The Architectural Design Review Committee (ADRC) held its regular monthly meeting on September 2, 2025, in Council Chambers, at 37 Green St, Concord, NH.

6.2 Kasada LLC, NES Group, Service Credit Union, and Bohler Engineering MA, LLC, request an architectural design review recommendation for a new 2,466-square-foot credit union, at Tax Map Lot 611Z 38, addressed as 285 Loudon Road, in the Gateway Performance (GWP) District. (2025-099) (PL-SPM-2025-0025, PL-ADR-2025-0119)

Elevations

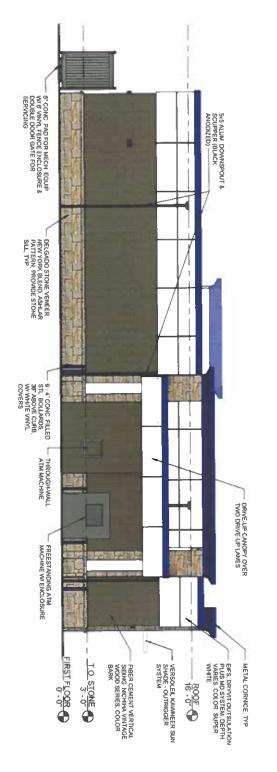
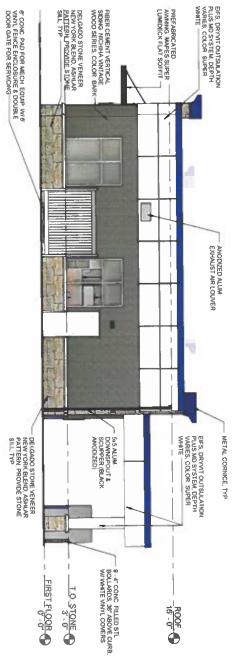
Member Thorpe noted the non-essential emergency or employee exit that is silhouetted in white and suggested not to do a white door and make it more background like the graphite gray siding to make disappear.

Co-Chair Hengen noted they have requested to increase the number of trees in northeast corner of the lot and the service doors are a dark color.

Mr. Chiudino stated they would have that painted to blend with the siding.

On a motion made by Co-Chair Hengen, seconded by Member Savage, the Committee voted to recommend that the Planning Board approve the application as submitted with the following conditions: increase the number of trees to be planted on the lot as much as possible, specifically, at least two additional shade tree shall be provided in the seeded lawn strip along the northern side of the site while still abiding by the required 10-foot separation from underground utilities; and, any service doors, not used for public access, shall be painted a dark color to complement the adjacent siding.
